RE: Louise Drive Extension
Franklin, MA
MassDEP NOI Number 159-1300
Project #: 3343-001-A01

DiPrete Engineering has received the peer review comments from BETA, received March 27, 2025. We have reviewed these comments and offer the following in response. The original comments are provided in italics with responses in bold. Note that the latest comments are labeled "BETA4", and comments "addressed" or "deferred to the Commission" per the aforementioned letter are shown in gray:

View from property corner to east of site: existing rock opening at low point adjacent to tree.

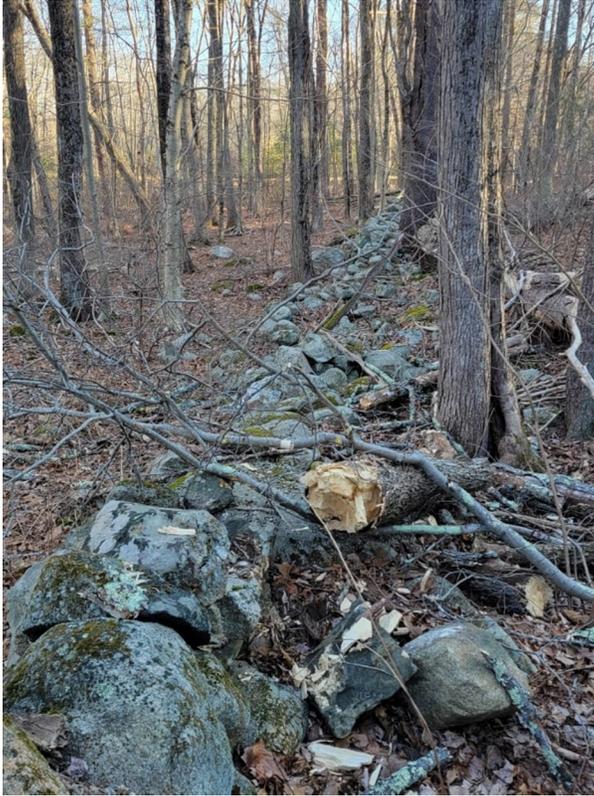
15. *SW15. The existing conditions plan identifies several stone walls located immediately downgradient of the outfall location. Demonstrate that these stone walls will not substantially impede flow discharged from the outfall.*

BETA3: BETA recommends that this low point be identified on the plans.

Per field visit on January 8th 2025, it was determined that the stone walls would not substantially impede flow as the grade slopes offsite to the northeast, and there are substantial openings in the stone wall offsite, in particular at a low point which appears to presently act as a natural weir:

The stone wall low point (spill-over location) has been identified on the Grading and Drainage Plan (Sheet 7).
